# UNITED STATES PATENT AND TRADEMARK OFFICE

APPLICATION NO.	FILING DATE	FIRST NAMED INVENTOR	ATTORNEY DOCKET NO.	CONFIRMATION NO.
10/624,648	07/23/2003	Masatoshi Mori	116473	6900
25944	7590	02/21/2006	EXAMINER	
OLIFF & BERRIDGE, PLC P.O. BOX 19928 ALEXANDRIA, VA 22320			THANH, QUANG D	
			ART UNIT	PAPER NUMBER
			3764

<b>Office Action Summary</b>	<b>Application No.</b>	<b>Applicant(s)</b>	
	10/624,648	MORI ET AL.	
	<b>Examiner</b>	<b>Art Unit</b>	
	Quang D. Thanh	3764

## DETAILED ACTION

FIG. 4

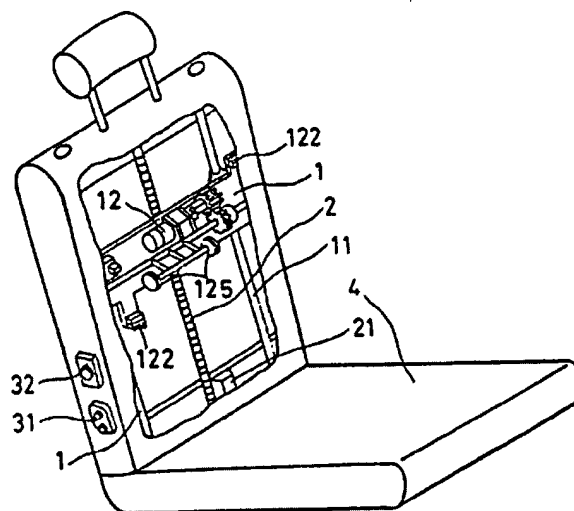
13. Claim 1 is rejected under 35 U.S.C. 102(b) as being anticipated by Hwang (5,184,607). Hwang discloses a seat with a massage mechanism comprising: a pair of brackets (see fig. 1 below) held on opposite sides of a base frame 3 such that they can move vertically (col.2, lines 2-4); a rod 1241 arranged rotatably relative to the brackets; and a push roller 125 held rotatably by the rod in a position eccentric from a rotational shaft center of the rod (best seen in fig. 1).
